Improved Technical Specifications

Quad Cities Station

Volume 2:
Sections 3.1 and 3.2

FIGURE 3.4.A-1

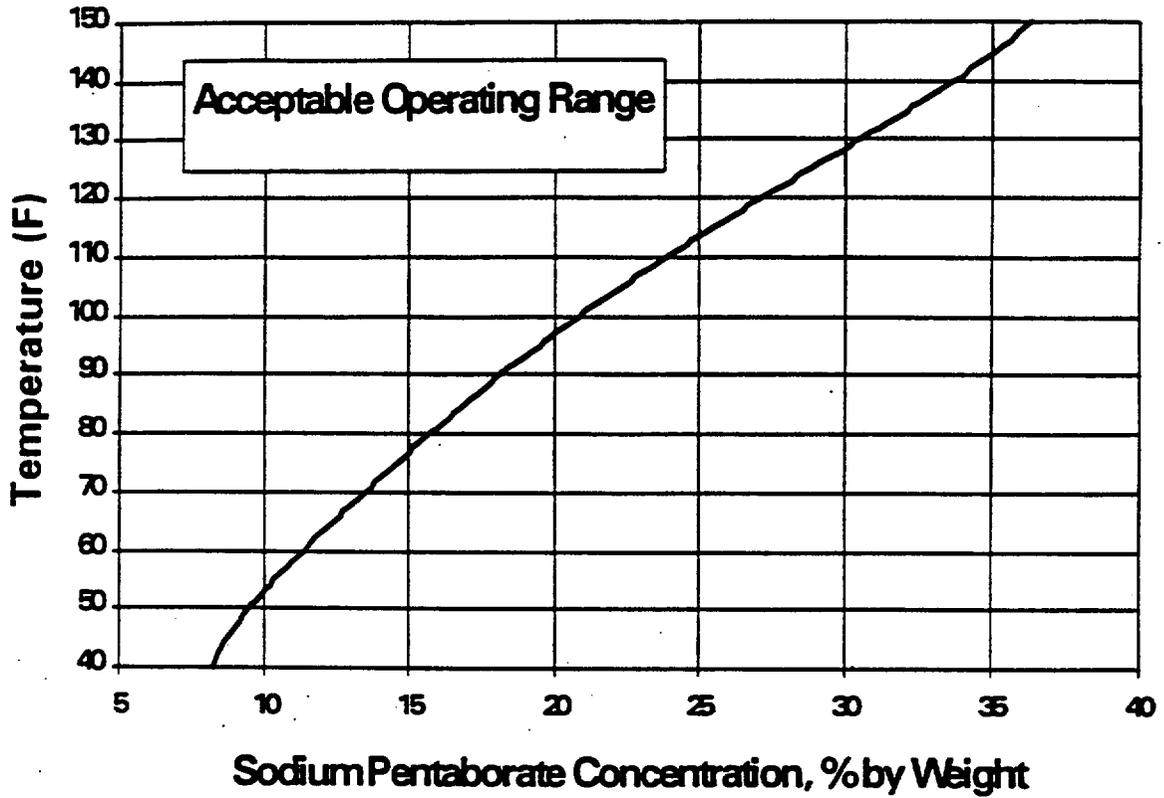
- M.2 (cont'd) Figure 3.1.7-2 (CTS Figure 3.4.A-1). This change is considered more restrictive since an explicit Surveillance will be required whenever the limits of Figure 3.1.7-2 are not met. However, this change is necessary since precipitation of the boron from solution may occur when the temperature requirements are not met.

Figure 3.1.7-2

Figure 3.1.7-1
FIGURE 3.4.A-2

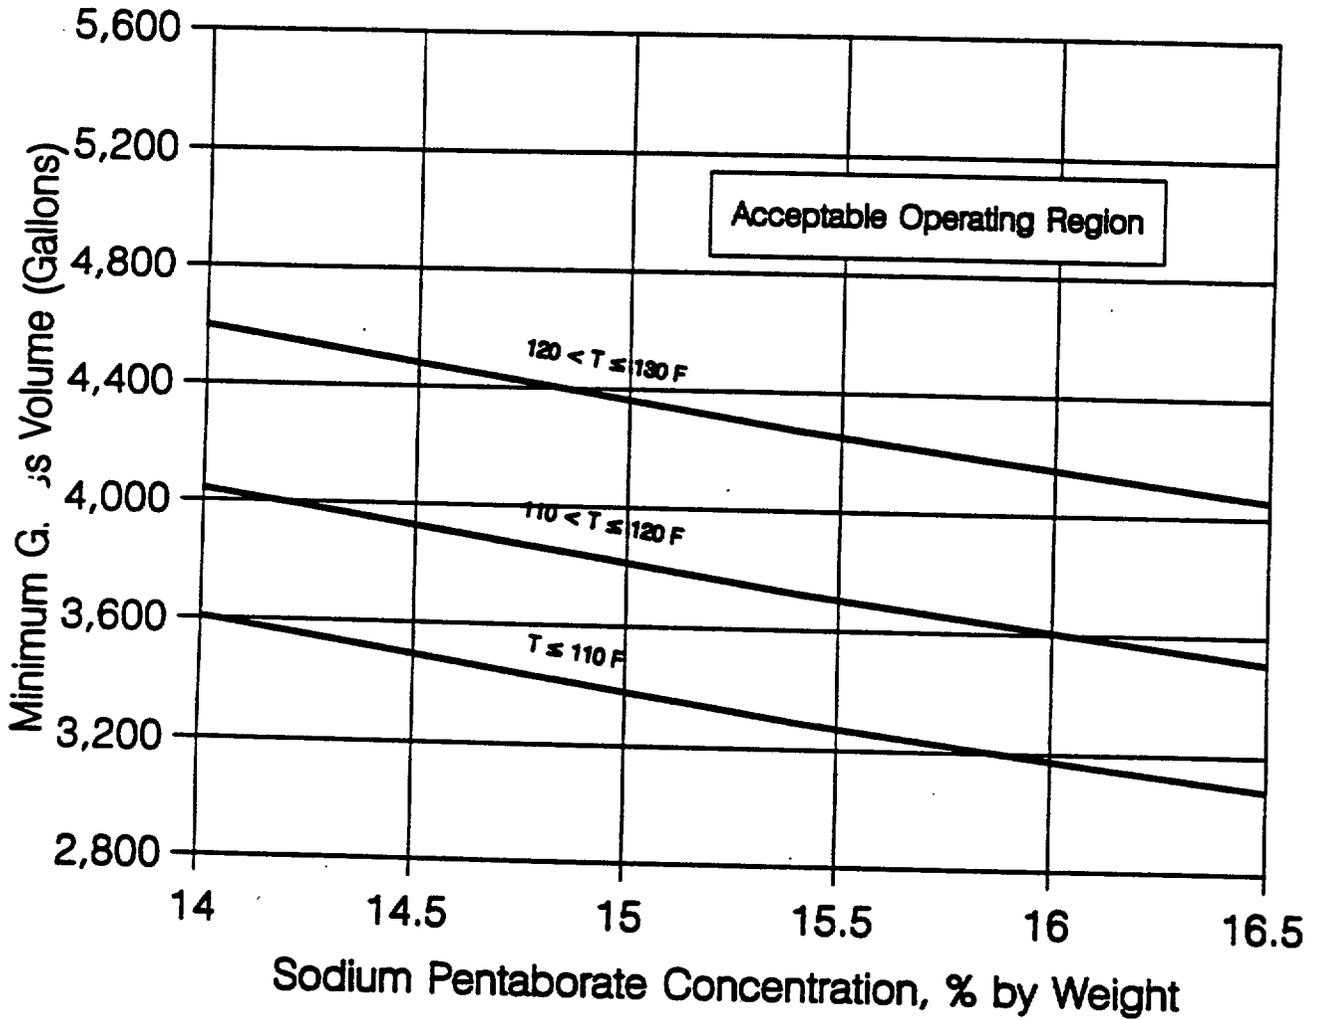
- A.3 The details of CTS 4.4.A.2.b, which identify the available boron concentration to be determined to be 14% to 16.5% by weight, are revised in proposed SR 3.1.7.5 to be within the limits of Figure 3.1.7-1. Since the limits identified in the Figure correspond to the same 14% to 16.5% by weight related to the volume requirement, this change is considered a presentation preference consistent with the BWR ISTS, NUREG-1433, Rev. 1. Therefore, this change is administrative.

Figure 3.1.7-1 (page 1 of 1)
Sodium Pentaborate Solution Volume
Versus Concentration Requirements

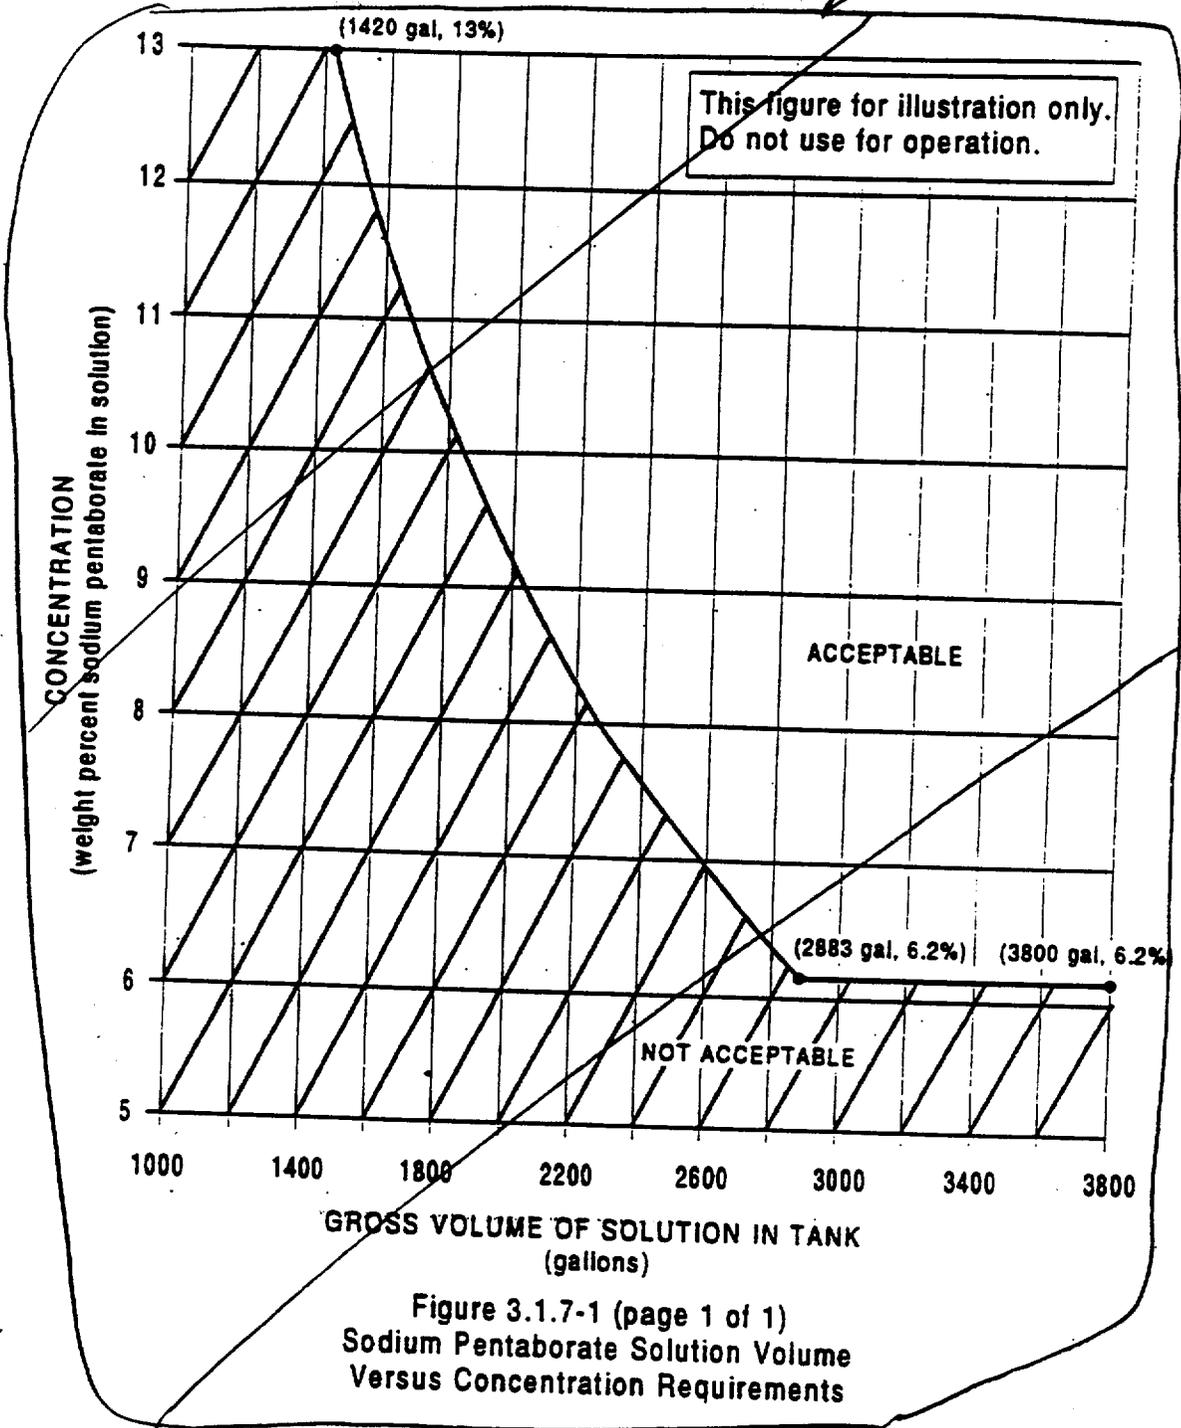
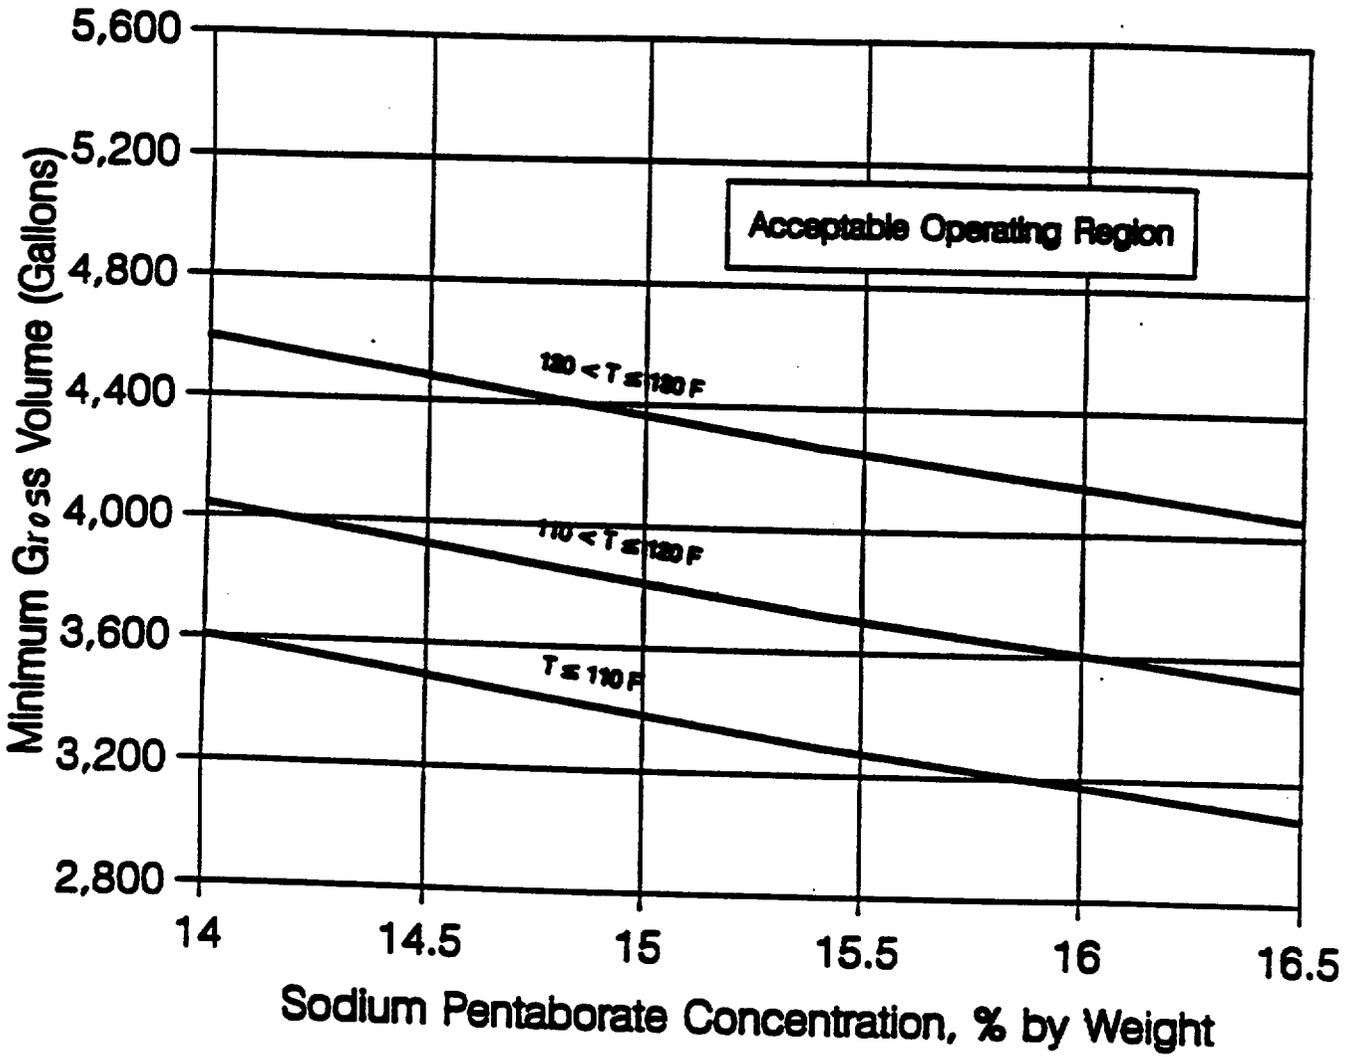
Insert Figure 3.1.7-1 ²

Insert Figure 3.1.7-1

2. The brackets have been removed and the proper plant specific information/value has been provided.
3. The proper Quad Cities 1 and 2 nomenclature has been used (CTS Figures 3.4.A-1 and 3.4.A-2). This is also consistent with the nomenclature used in SR 3.1.7.1 and SR 3.1.7.2.

Figure 3.1.7-2 (page 1 of 1)
Sodium Pentaborate Temperature Requirements

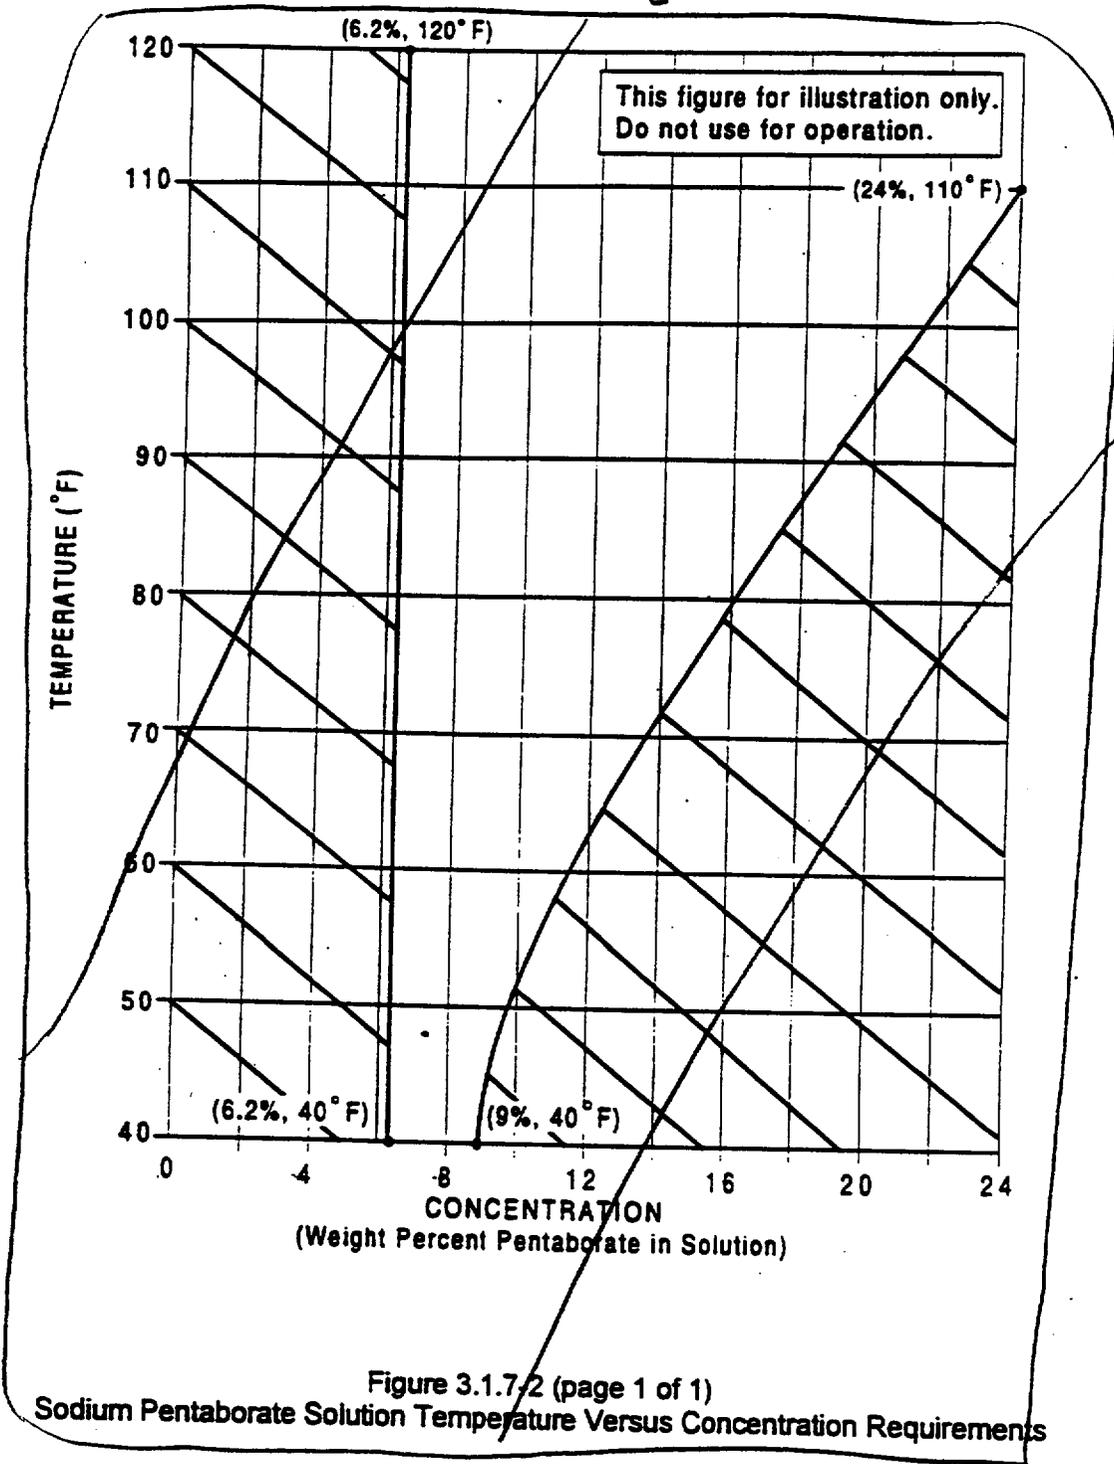
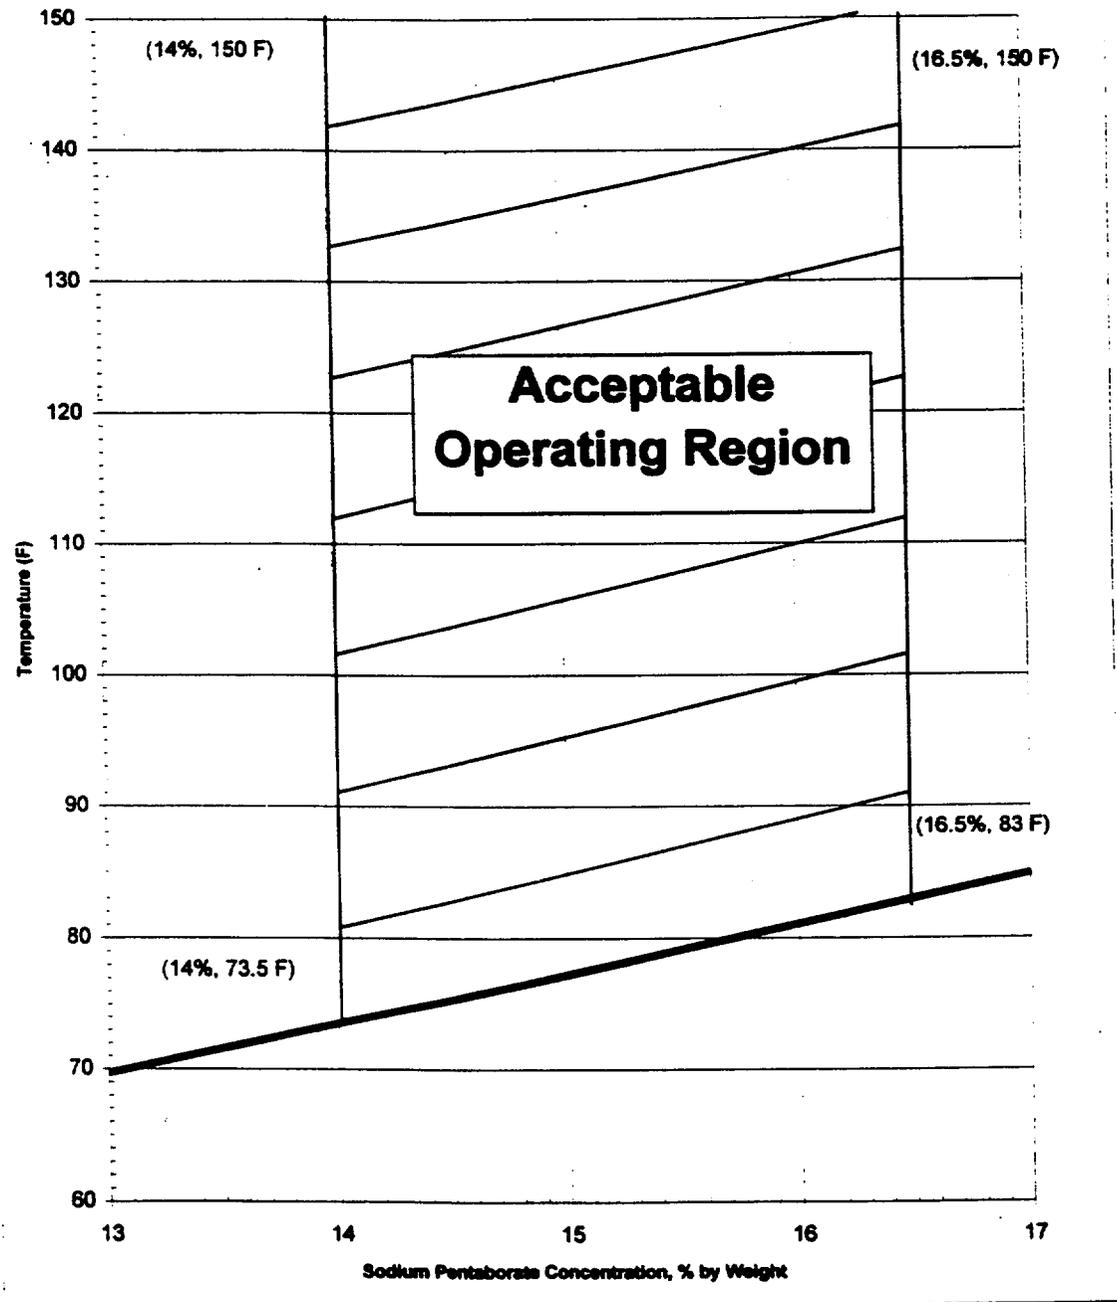
Insert Figure 3.17-2 [2]

Insert Figure 3.1.7-2
